Statement of Response to ABP's Opinion

**Proposed Strategic Housing Development at the Former
Magee Barracks Site, Hospital Street (R445),
Kildare Town, Co Kildare**

John Spain Associates

Ballymount Properties Limited

Figure 2.1: Net Site Area/ Residential Development Area

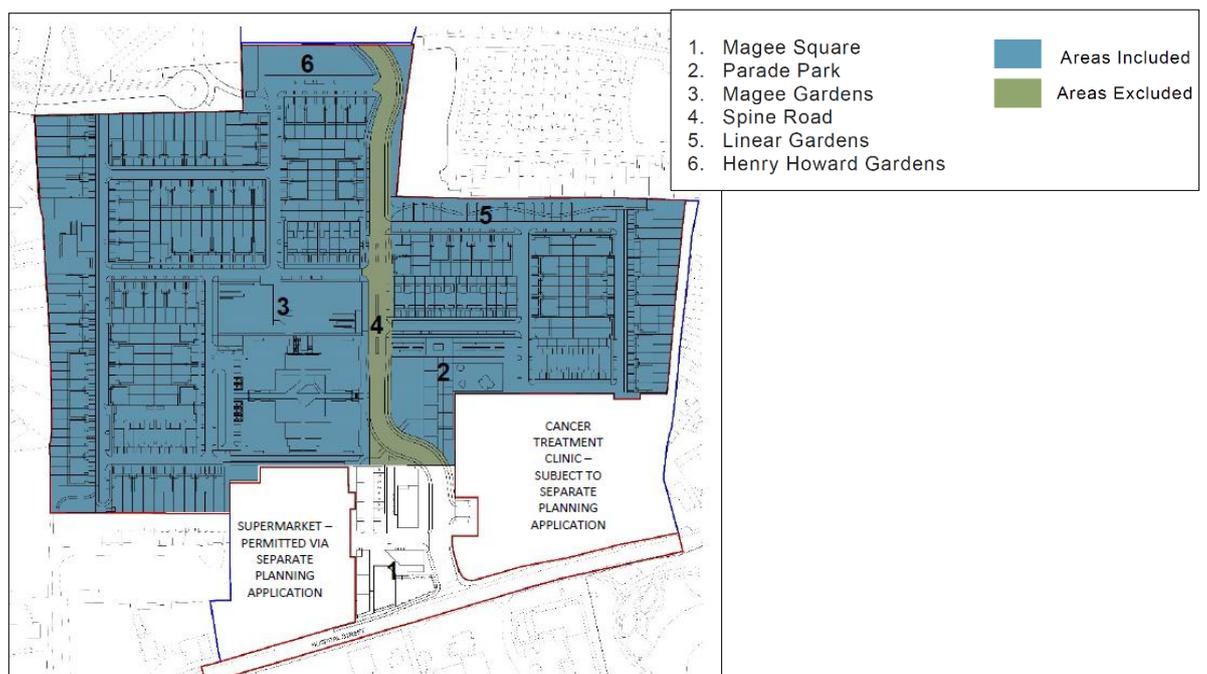
'Further consideration is required in respect of the documentation relating to the residential density of the proposed development. This consideration and justification should have regard to, inter alia, the minimum densities provided for in the 'Guidelines for Planning Authorities on Sustainable Residential Development in Urban Areas' (including the associated 'Urban Design Manual') as they refer to brownfield and inner suburban sites, and to the need to develop at a sufficiently high density to provide for an acceptable efficiency in serviceable land usage on a site close to the town centre of Kildare and its services and facilities, including public transport facilities, referred to in the Board's decision on application ABP-301371-18. The site area for the calculation of the net residential density should be delineated and measured in accordance with appendix A of the guidelines. This would exclude the land occupied by the spine road and neighbourhood centre, but not the proposed areas of open space that would mainly serve the needs of the residents of the scheme or the linear spaces along the edges of the site (which would not constitute significant landscape buffers within the meaning of appendix A of the guidelines). If the prospective applicant considers that the proposed open space at Parade Park should be omitted from the net site area for the calculation of the net residential density of the proposed development, then a justification as to why it should be regarded as an open space serving a wider area would need to be submitted'.

2.18 Having regard to Issue No.1 of the Board's Pre-Application Consultation Opinion which instructed that the net site area calculation should exclude "*the land occupied by the spine road and neighbourhood centre, but not the proposed areas of open space that would mainly serve the needs of the residents of the scheme or the linear spaces along the edges of the site (which would not constitute significant landscape buffers within the meaning of appendix A of the guidelines)*", the net site area calculation now only excludes the spine road and neighbourhood centre (Magee Square) as illustrated in Figure 2.1 below. Parade Park has not been excluded from the net site area. The net site area/ net residential development area has therefore increased from 76,975 sq.m to 95,139 sq.m.

2.19 In summary it is considered that the calculation of the net residential density has been delineated and measured in accordance with Appendix A of the Guidelines for Planning Authorities on Sustainable Residential Development in Urban Areas and in accordance with the requirements of the Board as outlined in Issue No.1.

Figure 2.2: 4 no. apartment blocks introduced to add variety in unit mix, height and density

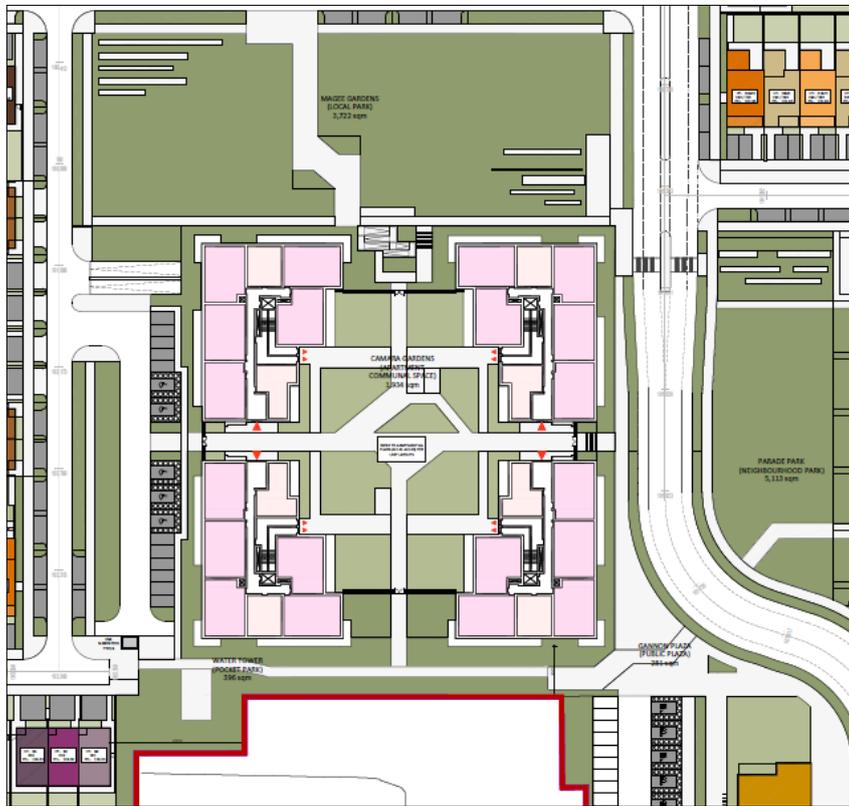
2.21 As a consequence of the revised calculation of net site area/net development area required by the Board, and to the need "*to develop at a sufficiently high density to*

provide for an acceptable efficiency in serviceable land usage on a site close to the town centre of Kildare and its services and facilities, including public transport facilities”, and having regard to the minimum densities provided for in the 'Guidelines for Planning Authorities on Sustainable Residential Development in Urban Areas' as they refer to brownfield and inner suburban sites, the revised proposals submitted now include 4 no. apartment blocks (south of Magee Gardens) which add variety to the overall unit mix and increase the proposed residential density on the subject site.
